## Changes to FCT Blade Bolts and Plates

Excerpt from an FCT 1460 parts list showing the new bolts and plate.

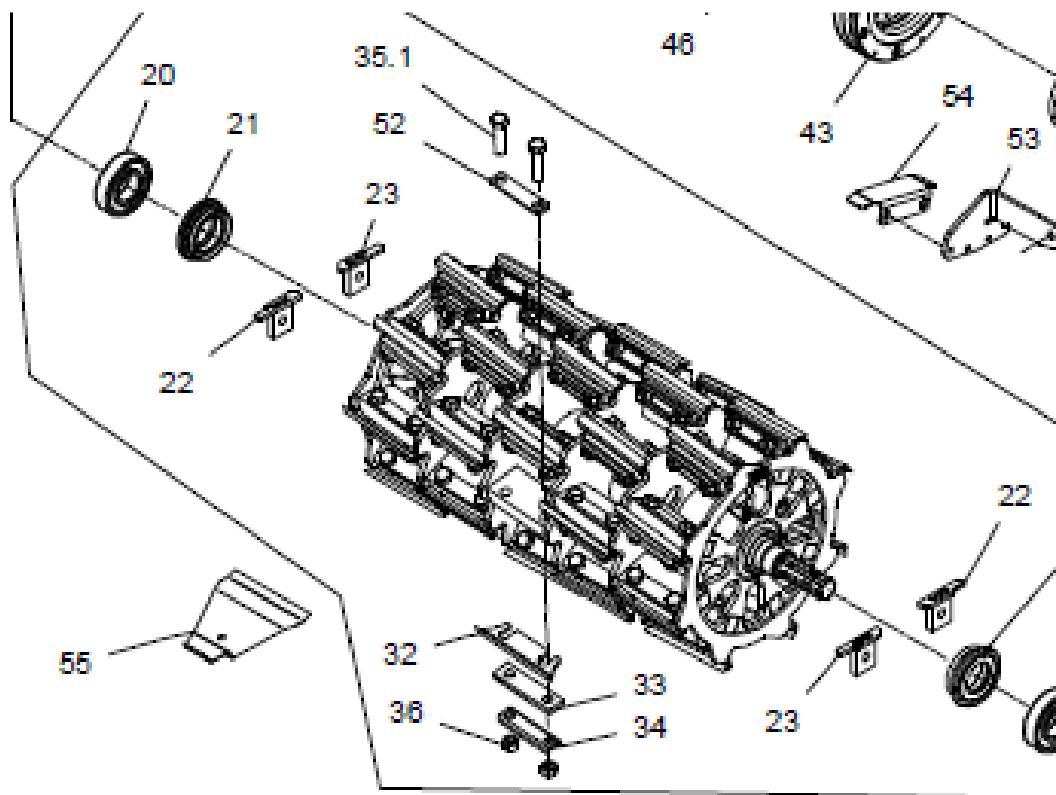
New bolts and spacer plates are being introduced on 2015 model FC/FCT foragers, the new part numbers are listed below. The new bolts are 80mm in length and fine threaded and an additional plate has been fitted. The new type bolts should be tightened to a torque of 400Nm.

These parts can be fitted to earlier 960/1060/1360/1460 machines but can only be **fitted as a complete set** to avoid putting the rotor out of balance and causing **severe damage** to the forager.

33	812064-134X	Plate	(unchanged)
34	812064-133A	Plate	(new type, harder locking plate)
36	811220-6119	Nut	(new type, fine thread)
35.1	811214-5333	Bolt	(new type, fine thread)
52	812068-204X	Plate	(additional plate)

If not replacing a full set on un-modified pre 2015 machines then 813064-428X bolt kit with 70mm bolt should still be used.
